CITY COUNCIL MEETING STAFF REPORT

DATE OF MEETING: June 18, 2019
NAME OF PROJECT: Whitaker Farms Subdivision
NAME OF APPLICANT: Luster Development
AGENDA ITEM: Final Approval
LOCATION OF ITEM: 455 North River Road
ZONING DESIGNATION: RA-1-43

Subject: Whitaker Farm Subdivision –Final Plan Review

LANDSCAPE PLAN

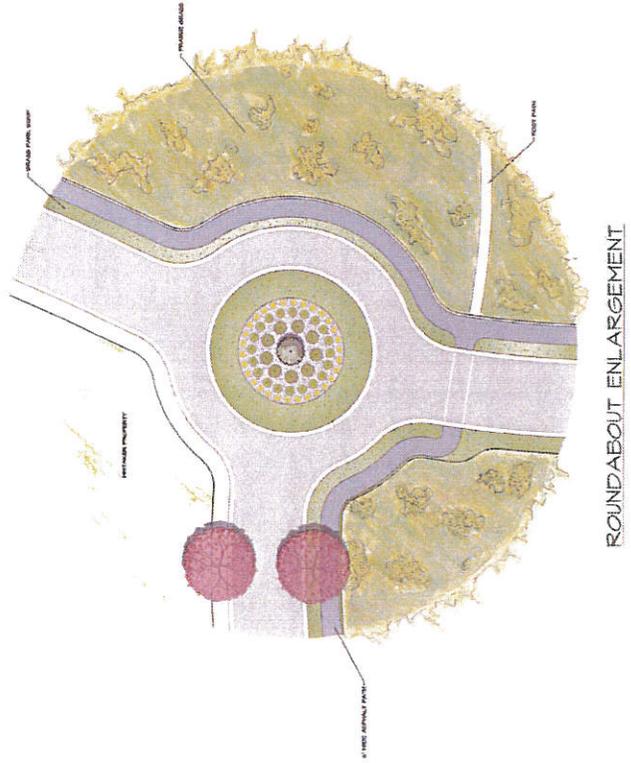
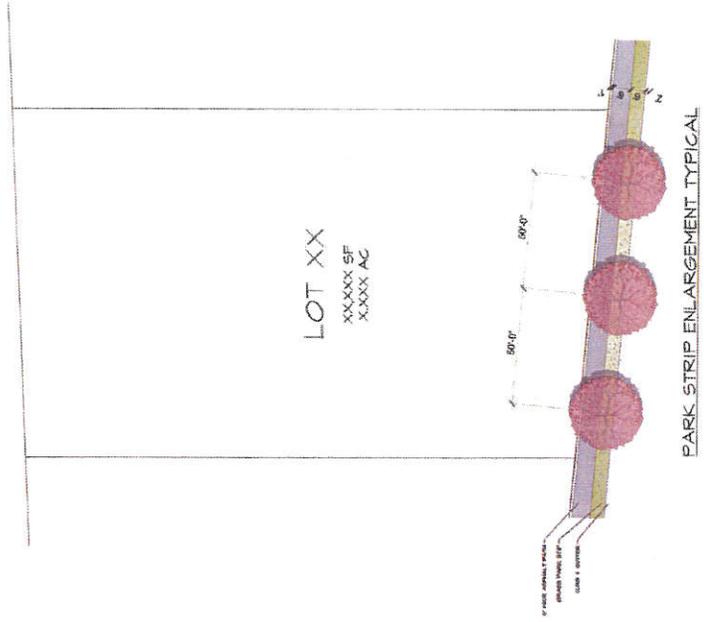
Landscaping Plan – A landscaping plan has been submitted to the City and a copy is attached to this report. Staff has concerns about the proposed prairie grass and the maintenance of the prairie grass. The developer has stated that the prairie grass will be cut, at a minimum, three times each year. Language will be included in the development agreement regarding maintenance of the prairie grass.

WHITAKER FARMS ROUNDABOUT @ 600 N & RIVER RD
 McHenry, Ill

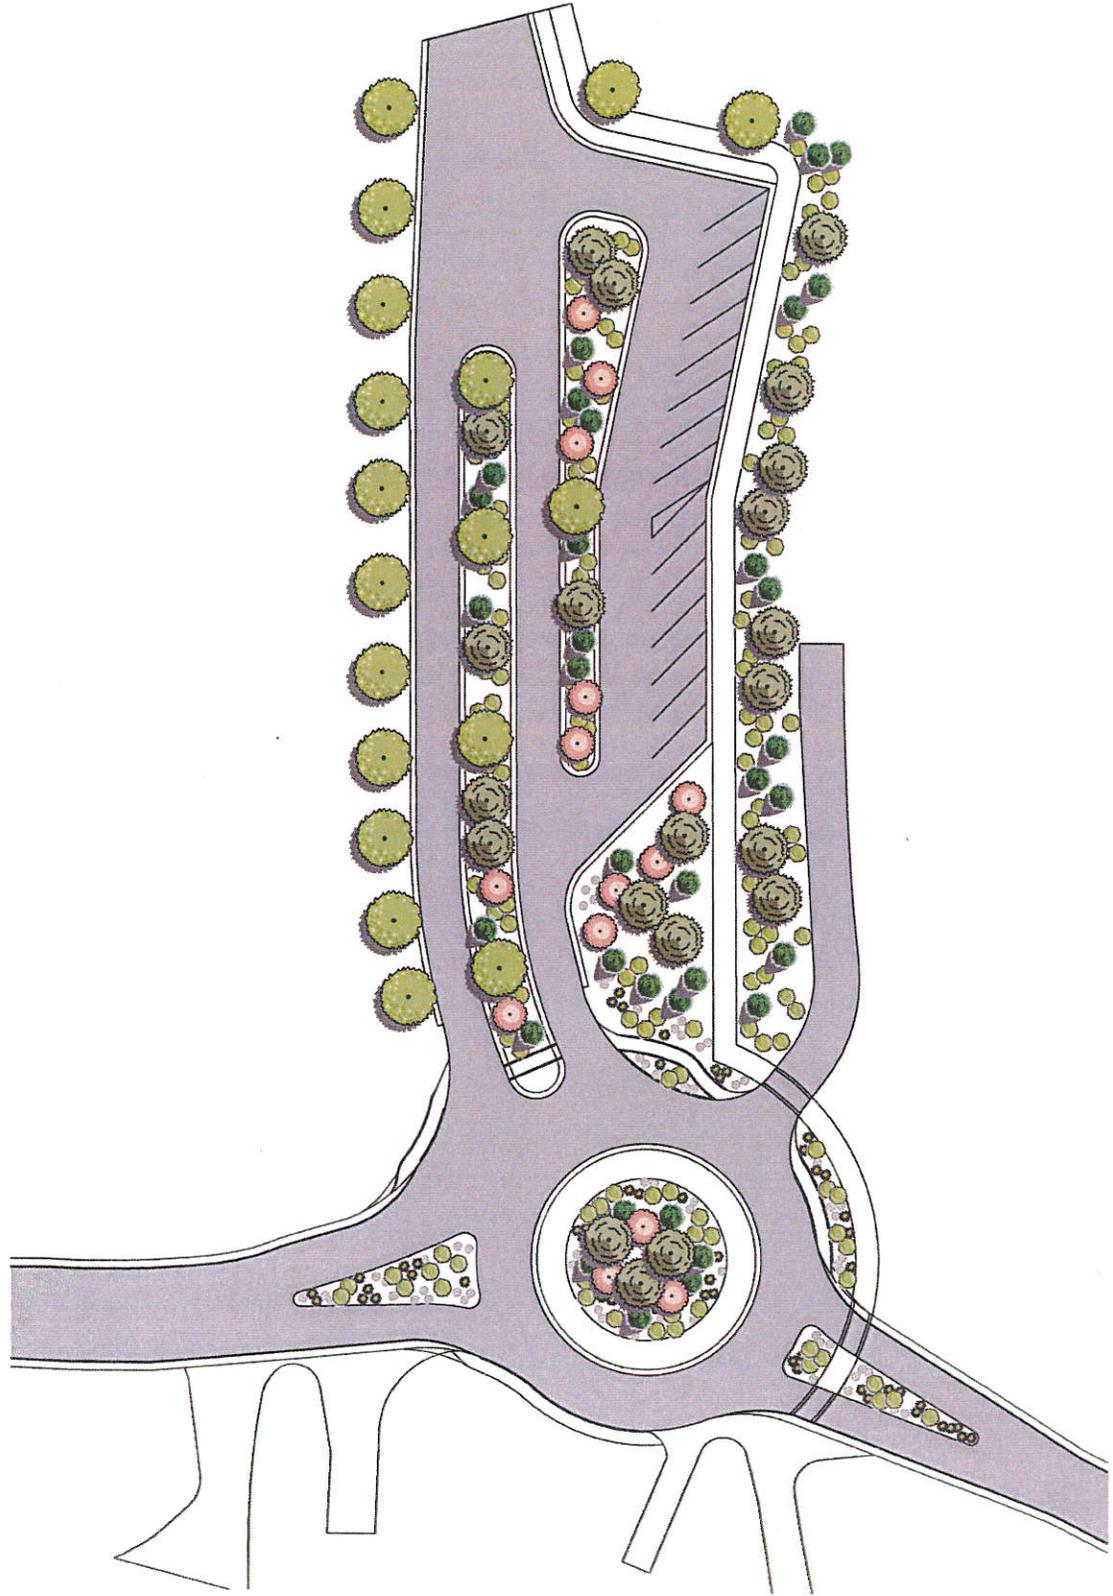
Roundabouts – The developer has proposed two roundabouts as part of the development. The two roundabouts were included as part of an annexation agreement amendment. The roundabouts serve several purposes including slowing traffic, allowing River Road to remain a two lane road thus, preserving a rural atmosphere, beautification and aesthetics, deterring through traffic, creating a safe intersection where multiple accesses meet River Road at the base of Memorial Hill, and helping to create better parking for Memorial Hill. The City has diligently worked with Wasatch County and the developer to facilitate the approval process of the Memorial Hill roundabout because the City feels the proposed plan has many benefits to the residents of Midway and Wasatch County. Since some of the property where the roundabout will be located is owned by Wasatch County, their approval is required for the proposal to move forward. As of the writing of this report, Wasatch County has not approved the proposed plans. The developer has offered to bond for all infrastructure costs of the roundabout so that the project can move forward but this presents issues that must be considered regarding granting final approval of the

subdivision. Without County approval of the roundabout before final approval is granted there is no guarantee that the proposed plan will ever be possible. Bond money will cover the cost but without approval cannot be used. Which would leave the proposal without two approved points of access. The developer has submitted a plan B proposal (which has yet to be engineered) that appears to meet code requirements but there are other issues that will need to be worked out such as trail access to Memorial Hill, which is important to the trails master plan. The question is, does the City Council feel that plan B is an acceptable option or not? If it is acceptable then the City could grant final approval for both options. The Memorial Hill roundabout would be the preferred option and a condition could be required that would allow the developer several months to receive approval from the County. If approval is not obtained in the specified time period, then the developer would have to build plan B. Bonding would need to cover the maximum cost required by code for either option. All the details, such as trails, would still need to be discussed.
